Office Action Summary	Application No. 10/550,463	Applicant(s) GAMBIRASIO ET AL.	
	Examiner Omar Rojas	Art Unit 2874

DETAILED ACTION

Fig.4**Fig.14**

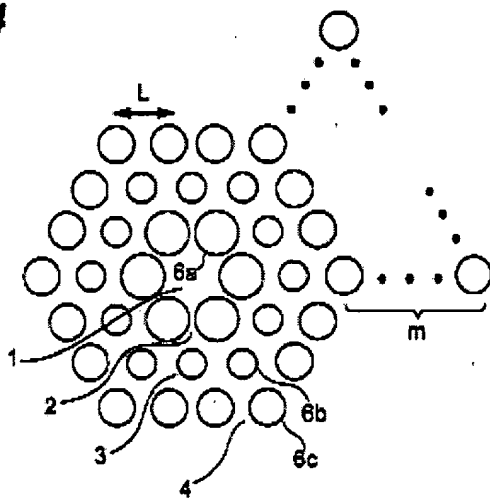
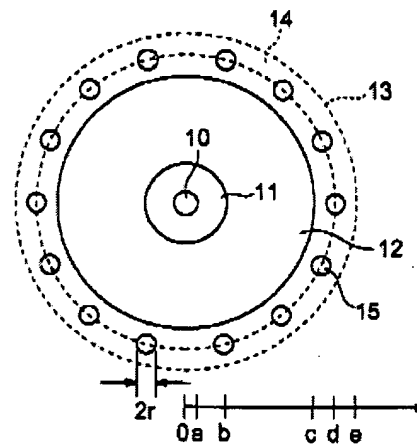
In re claims 19, 20, 23, 24, 32, and 36, the Sumitomo document discloses a microstructured optical fibre (e.g., Fig. 14) comprising a core region 10 with a material having a refractive index n_0 and a microstructured region 13 surrounding the core region 10 with a background material having a refractive index n_{31} which is lower than the refractive index n_0 , the microstructured region comprising a plurality of microstructures 15 having a refractive index n_{32} different from the refractive index n_{31} , the distance L between the centers of any couple of adjacent

microstructures 15 ranging from about 1.48 μm to about 6.2 μm , thereby overlapping the range between λ_p and $1.5 \lambda_p$ as claimed. See ¶¶ [053],[054],[061], and [076]-[080]. Figures 4 and 14 of Sumitomo are reproduced below.

Fig. 11

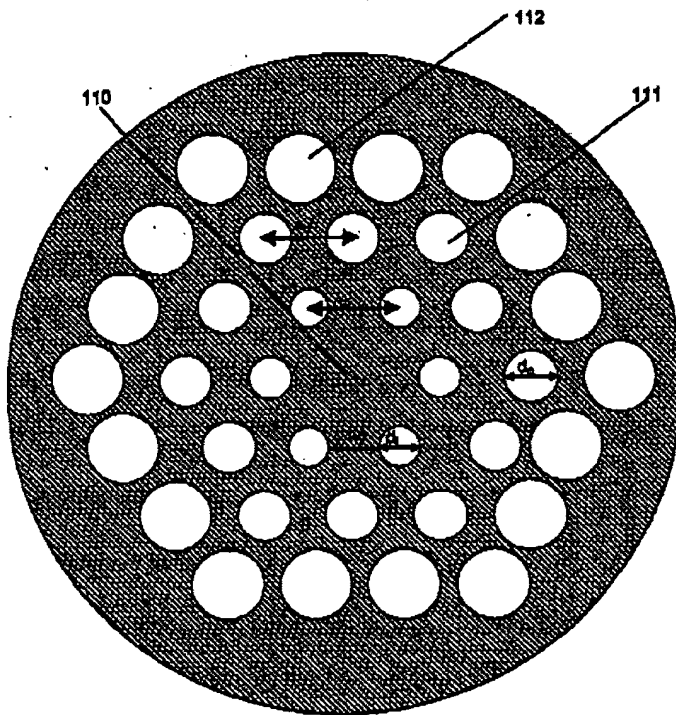
In re claims 19, 20, 23, 24, 32, and 36, Broeng discloses a microstructured optical fibre (e.g., Figs.10-14) comprising a core region 104/110/120 with a material having a refractive index and a microstructured region 101 surrounding the core region with a background material having a refractive index which is lower than the refractive index of the core region (col. 9, lines 3-7), the microstructured region comprising a plurality of microstructures 110/111/112/121/122 having a refractive index different from the refractive index of the background material (col. 14, lines 29-

31), the distance Δ between the centers of any couple of adjacent microstructures overlapping the range between λ_p and $1.5 \lambda_p$ as claimed. See Broeng at columns 17-20. Figure 11 of Broeng is reproduced below.
